APPLICANT EVALUATION
JOYNER - FLETCHER REPORT

VIRGIL C. SUMMER NUCLEAR STATION
DOCKET NO. 50/395
SOUTH CAROLINA ELECTRIC & GAS COMPANY
OCTOBER - 1981

APPLICANT EVALUATION OF JOYNER AND FLETCHER REPORT ON
VIRGIL C. SUMMER NUCLEAR STATION
SEISMICITY STUDIES

FIGURE 1

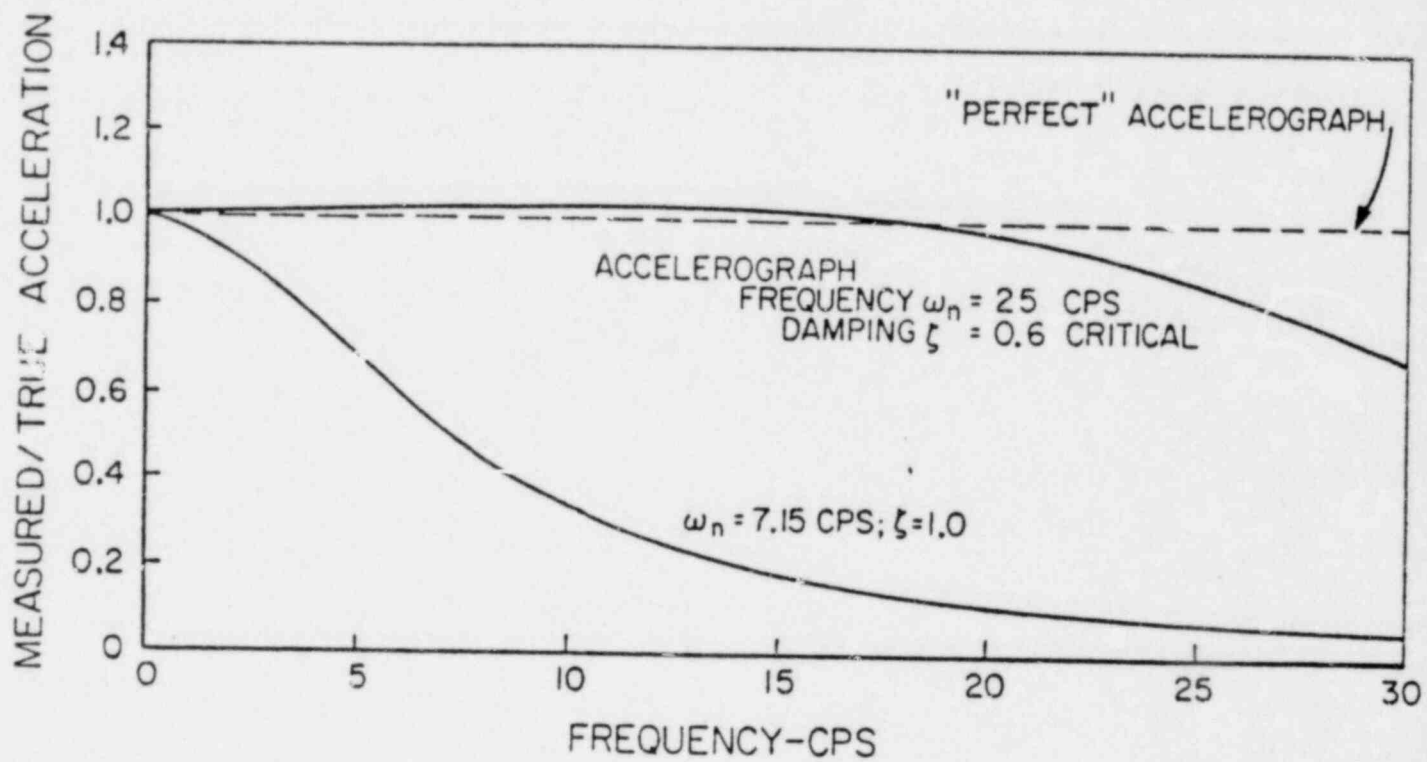
Typical strong motion instruments, including the one installed at Jenkinsville, have a natural oscillation frequency of 25 hz, meaning that the instrument itself tends to damp out motion at higher frequencies. Joyner and Fletcher have taken 25 hz as the upper limit of motion that can be recorded. However, accelerographs can easily record frequencies higher than their natural frequency. The upper solid curve in Figure 1 shows the response of an accelerograph with natural frequency of 25 hz and damping 0.6 of critical (the characteristics of the SMA-1 accelerograph at Jenkinsville, according to Brady et al., 1981) plotted as a function of frequency. Not only can the accelerograph itself record frequencies higher than 25 hz, but standard record processing procedures (including those used by Brady in the above reference) "correct" for the instrument response, effectively by dividing the recorded ground motion at each frequency by the ordinate on Figure 1. This effect can be significant: the peak acceleration of the "2nd aftershock" record, 90° component, documented by Brady et al. (1981), increases 35 percent due to instrument correction procedures.

FIGURE 2

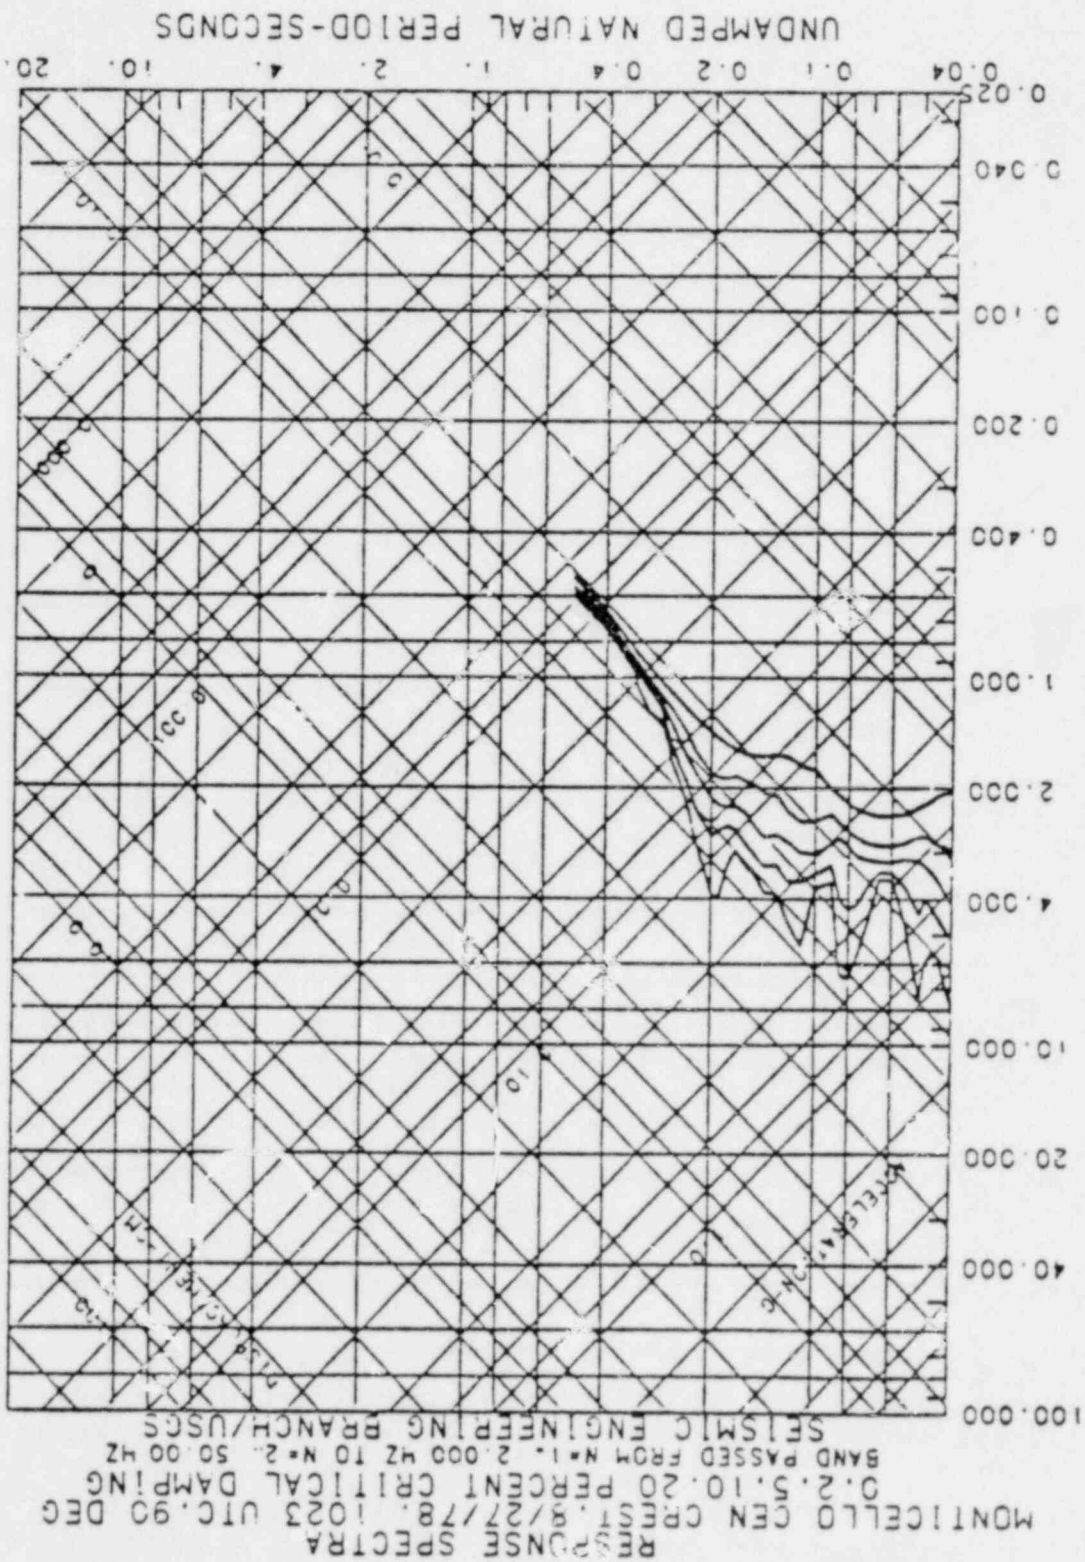
provided by Brady et al. (1981), one of which (August 27, 1978 earthquake 90° component) is reproduced here as Figure 2. Although spectra are only plotted down to a period of 0.04 seconds (up to a frequency of 25 hz), it is evident that there is no decrease of energy near 25 hz, and it is safe to assume that the spectra, if plotted at higher frequencies, would continue horizontally to frequencies as high as 35 or 40 hz, and this would indicate ground motions at those frequencies.

The Applicant has used an upper frequency of 40 hz to accurately characterize these records, making it clear that it is the record corrected for instrument response and digitized at 500 points per second to which this upper bound applies. The choice of upper bound f_u affects estimates of stress drop $\Delta\sigma$ in the following way:

FIGURE 3

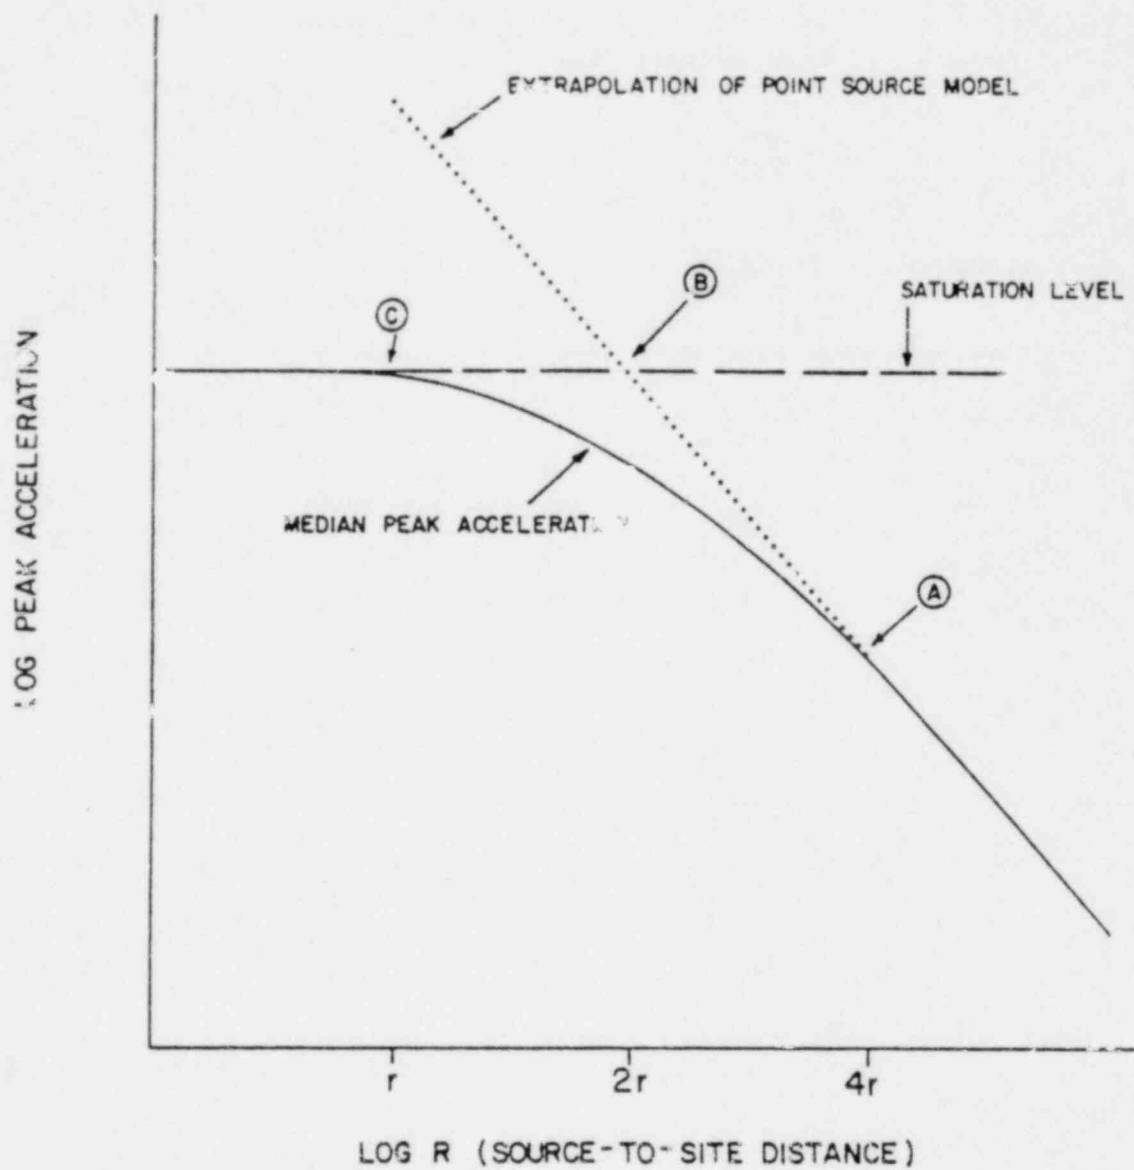
diameter ($R=2r$) gives a reasonable approximation to the saturation level." This is stated in Appendix XI of the Supplemental Seismological Investigation Report. This statement is illustrated in Figure 3 as point B, where the dotted line and dashed line cross. Whether or not Joyner and Fletcher agree with these statements, they are consistent, and the Applicant has not, "introduce(d) distance saturation in a slightly different way in Appendix XI ...," as Joyner and Fletcher state.

The Applicant notes that Joyner and Fletcher do not propose any alternative to choosing saturation distance by scaling by source size. Further, Joyner and Fletcher's mention of $R=r$ as the saturation distance appears to be motivated more by where ground motions are anticipated to decrease from any saturation level (point C on Figure 3) than what distance is appropriate to extrapolate point source models.
